PLANNING COMMISSION STAFF REPORT

Originator Cary Teague Community Development Director	Meeting Date February 12, 2014	Agenda # VI.C.
---	--	--------------------------

Homestead Partners LLC is proposing to subdivide the properties at 6304 and 6312 Warren Avenue into three lots. (See property location on pages A1–A3.) The existing two homes would be torn down, and three new homes built on the new lots. (See applicant plans on pages A4–A12.) To accommodate the request the following is required:

PRELIMINARY SITE & UTILITY PLAN
 WYMAN PLACE
 Edina, Minnesota

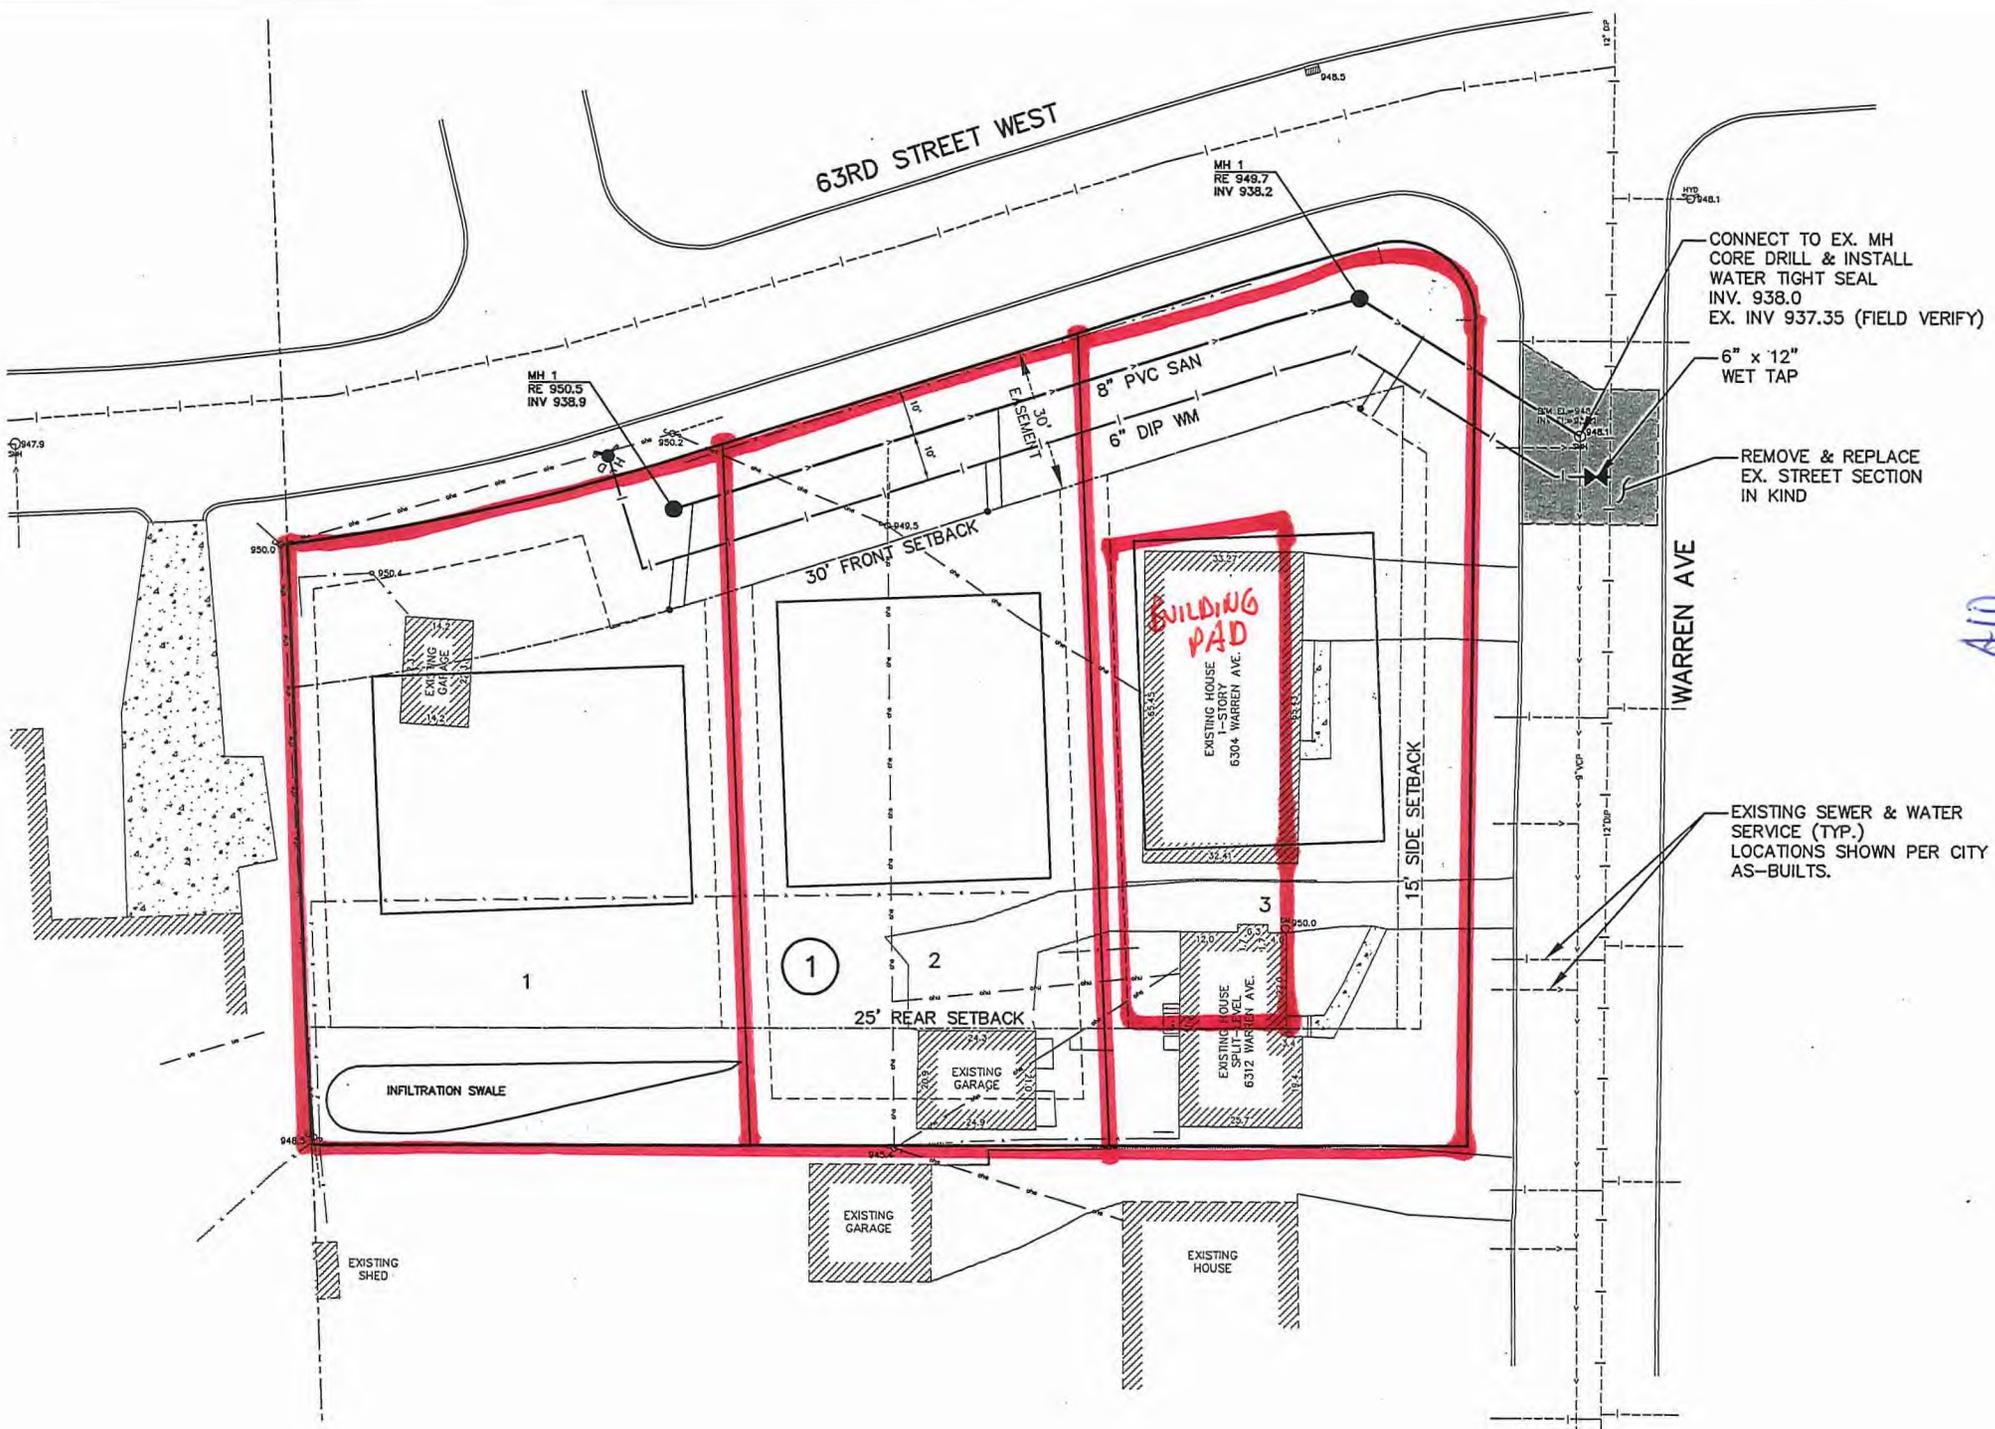
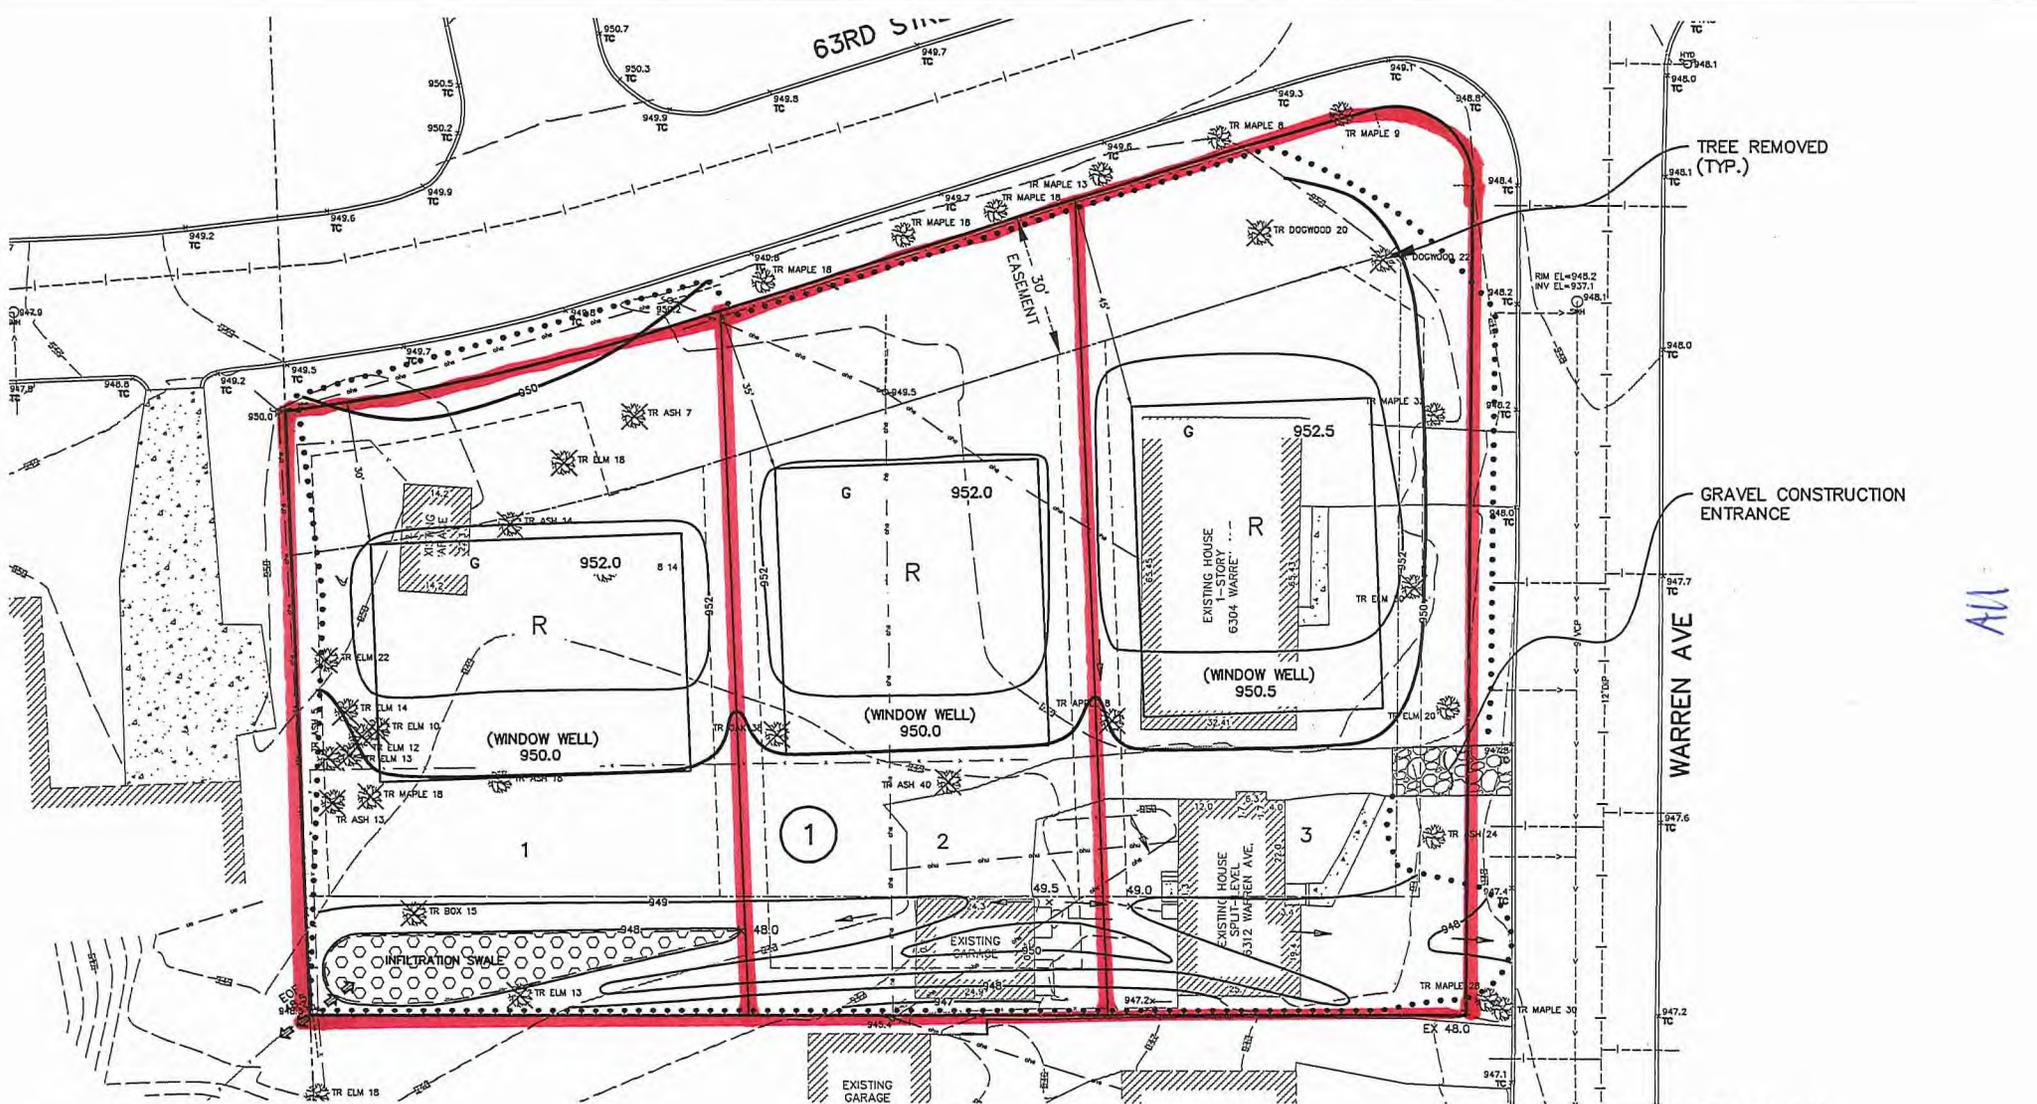
The city engineer has reviewed the proposed plans and found them generally acceptable, with a few revisions. First, the sewer line should be extended in the street, not in the front yard of the private property, as proposed. (See page A10.) Second, water connections should be made directly from the street, rather than as proposed, which would run new water lines into the site across the front yards of the new lots. (See page A10.) These changes would minimize impacts to the front yards of the new lots, and allow future maintenance of the utilities outside of the private property within the right-of-way. Drainage and utility easements should be adjusted accordingly on the Final Plat.

2. Park dedication fee of \$5,000 must be paid prior to release of the final plat.
3. Sewer line must be extended in the street, not in the front yard of the private property. Water connections shall be made directly from the street.

4. Drainage and Utility Easements shall be revised on the Final Plat to reflect removing the sewer and water lines from the front yards of the three Lots. The easement along the front lot lines (63rd Street) shall be 10 feet.
